# UNITED STATES PATENT AND TRADEMARK OFFICE

10/710,253

<b>Office Action Summary</b>	<b>Application No.</b>	<b>Applicant(s)</b>	
	10/710,253	HOHMANN ET AL.	
	<b>Examiner</b>	<b>Art Unit</b>	
	Katherine W. Mitchell	3677

## **DETAILED ACTION**

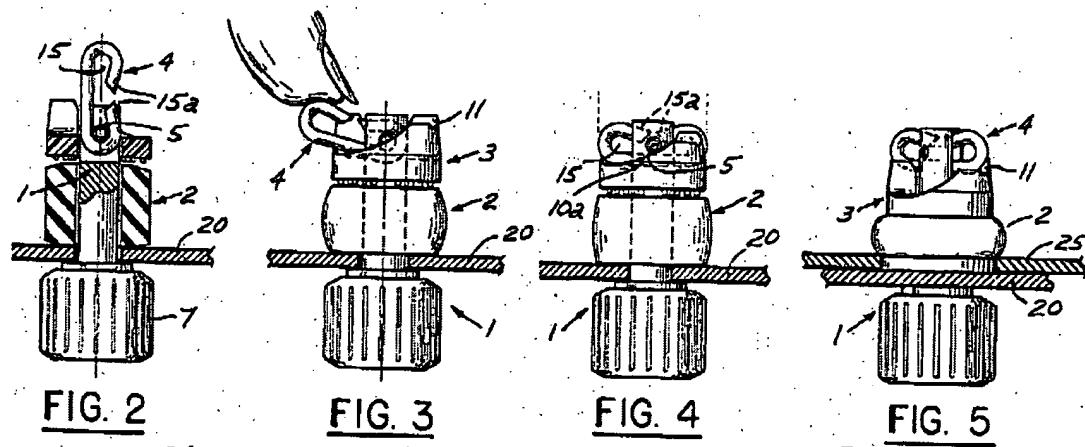
5. Claim 24 is rejected under 35 U.S.C. 112, second paragraph, as being indefinite for failing to particularly point out and distinctly claim the subject matter which applicant regards as the invention. How can 3 cut outs be disposed approx. 90 degrees apart

from each other? Looking at Fig 1 and 2,

"40" on the upper shaft is 90 deg apart from "40" on the shaft end, but it is certainly NOT 90 deg apart from the unshown "40" on the underside of shaft -- those are 180 degrees apart from each other.

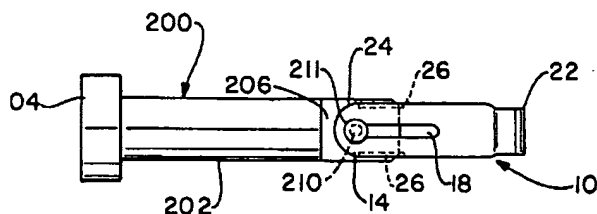
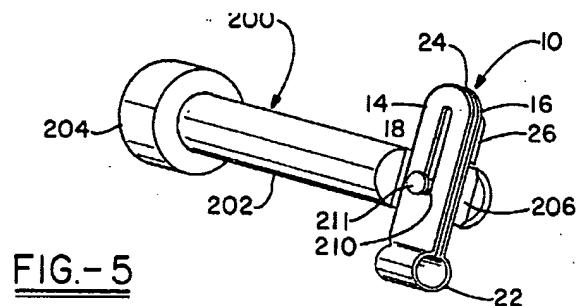
8. Claims 27-29 are rejected under 35 U.S.C. 102(b) as being anticipated by Modrey USP 3279302.

Modrey teaches an integrated pin and clip, comprising a shaft 6 with a locking member 4 at a first end of said shaft, with the locking member movable between a 1<sup>st</sup> position and a 2<sup>nd</sup> position wherein the locking member 4 is generally coaxial with said shaft in 1<sup>st</sup> position (Fig 2) and perpendicular to said shaft in said 2<sup>nd</sup> position (Fig 3), and a retaining means (cam/sleeve/pin interaction, col 2 lines 9-52 and col 4 lines 5-64), such that compressive force and its release secures the locking member in said first position and said 2<sup>nd</sup> position. In this case, 2<sup>nd</sup> position is the intermediate position

shown in Fig 3, where the locking member extends from only one side of the shaft, and in this 2<sup>nd</sup> position, the locking member is generally perpendicular to the shaft.

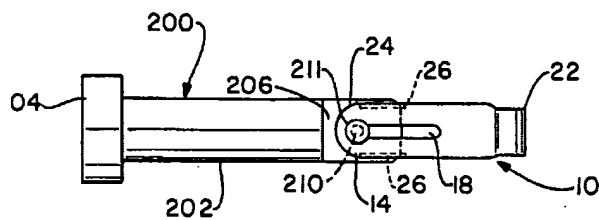
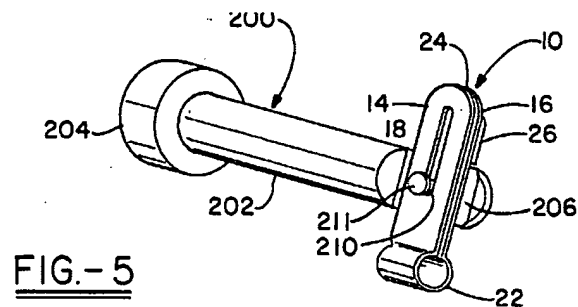
13. Claims 27-31 are rejected under 35 U.S.C. 103(a) as being obvious over Collister USP 5507611.

Collister teaches an integrated pin and clip, comprising a shaft 202 with a locking member at a first end of said shaft, with the locking member movable between a 1<sup>st</sup> position that is *generally* coaxial with the shaft member and a 2<sup>nd</sup> position that is perpendicular to the shaft member, a retaining means (spring action such that locking member acts like tweezers with retaining wings 26, such that compressive force and its release secures the locking member in said first position and said 2<sup>nd</sup> position.

However, Collister fails to teach that the locking member extends from only one side of the shaft. Absent some showing of criticality, the claimed shapes are nothing more than several of numerous shapes a person of ordinary skill in the art would find obvious for the purpose of providing a locking pin to a shaft. In re Dailey 149 USPQ 47 (CCPA 1976). Further, changes in size or shape without special functional significance are not patentable. *Research Corp.v. Nasco Industries, Inc.*, 501 F2d 358; 182 USPQ 449 (CA 7) cert. Denied 184 USPQ 193; 43 USLW 3359 (1974). As long as the end is blocked from being removed from a hole, there would be times when having the locking member extend from only one side would obviously be beneficial to one of ordinary skill in the fastener arts-- when there is insufficient clearance or cramped space, for example.

A portion of the locking member is cylindrical - end 22.

There is a cut out on the outer surface of the shaft (206) sized to receive the locking member in seating engagement and retain the locking member in the 2<sup>nd</sup> position. (Fig 5). The locking member is adapted to be pulled out of engagement with the cut out to allow rotation between 1<sup>st</sup> and 2<sup>nd</sup> positions.
